Dampier Bunbury Natural Gas Pipeline (DBNGP)

REVIEW OF DBNGP REVISED ACCESS ARRANGEMENT (AA6) 2026 - 2030

Report prepared for:
ECONOMIC REGULATION
AUTHORITY (ERA) OF
WESTERN AUSTRALIA

October 2025

Figure 2.2: Proportion of cost by service category

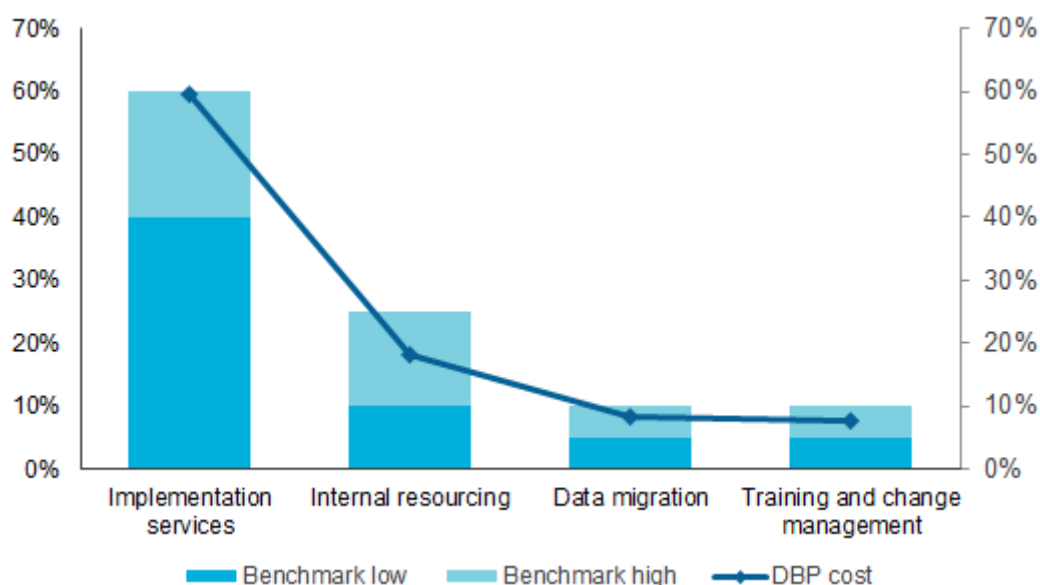
95. We first considered the extent to which the grouped items of expenditure fall within a reasonable proportionate range for IT projects of this nature. To assist this, we collated generic information on indicative proportionate breakdown for SAP S/4HANA implementation costs and we provide the comparative results of this analysis in Figure 2.2.
96. In broad terms, our analysis indicates that DBP's costs were broadly within the range of proportions for each 'category' of services undertaken, though with Implementation Services costs at the top of the range. This is consistent with this category including the implementation services of the original vendor and the replacement vendor, and with the extended amount of 'project management' and assurance, which also involved two providers.

98. While we need to stress that this analysis is based on proportions of DBP's total cost and does not in itself validate that total cost itself as 'prudent and efficient', it does indicate that DBP's costs incurred for internal resourcing, data migration and training and change management were not proportionate outliers. This is relevant because, as we show in Table 2.6, DBP's budget estimates, including for its original AA5 allowance, had significantly smaller allowances for 'external technical' and 'AGIG project resources' than were eventually incurred. We consider that this supports a view that the variance at least for these components, relates more (though not necessarily wholly) to budget underestimation than to cost inefficiencies.

Figure 2.3: Comparison of peer ERP implementation costs - \$m 2024

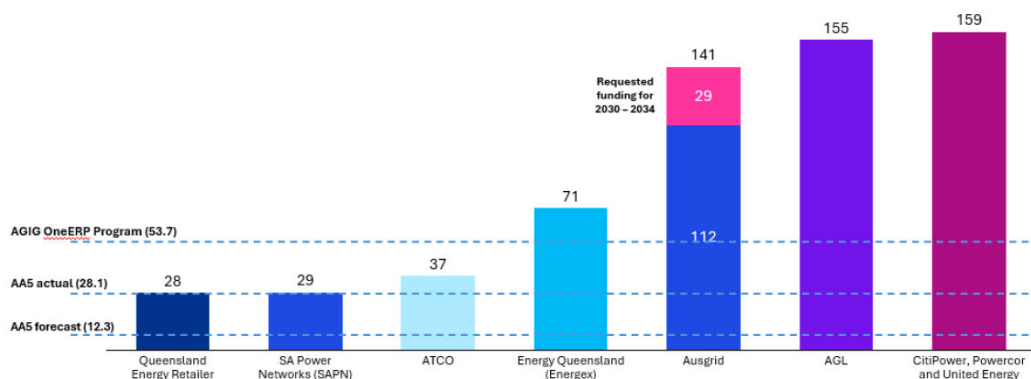
104. We consider that the benchmarking information is consistent with DBP’s claim that its original estimate of \$12.9m was understated. However, we consider that it does not provide the support that DBP claims for the comparability of its eventual actual cost. We make the following observations:

- The DBP ‘AA5’ figure of \$28.1m is also not a valid comparative amount, as this is only DBP’s AA5 expenditure, and does not represent the total cost even to DBP and which included expenditure in AA4.

- The figure shown in the KPMG graph is misleading for ‘Energy Queensland’. The graph qualifies this as being for Energen, however Energy Queensland is an entity that encompasses both Energen and Ergon and IT is provided by Energy Queensland for both DNSPs. In Table 17 of the Energy Queensland business case, the costs are
